Product: **DGN/S1.16.1 DALI Gateway emergency 1f, 16G, MDRC**

Software-Information

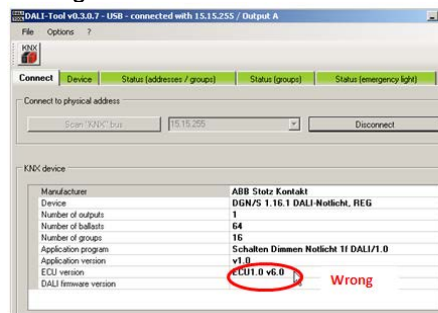
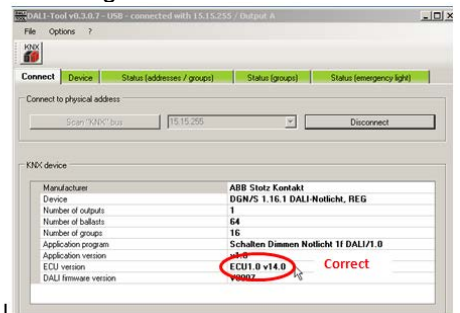
Between March (KW9/2013) and August (KW31/2013) DGN/S1.16.1 was delivered with wrong ECU Firmware. Though this it can happen, that DGN/S 1.16.1 is not visible on KNX. This is also visible that the KNX programming status of DGN/S is no longer displayed in ETS.

With DALI config Tool it is possible to read ECU firmware.

Wrong/Fault ECU1.0 v6.0

All right ECU1.0 v14.0

DGN/S 1.16.1 with wrong Firmware has to be replaced. An update is only possible in factory.
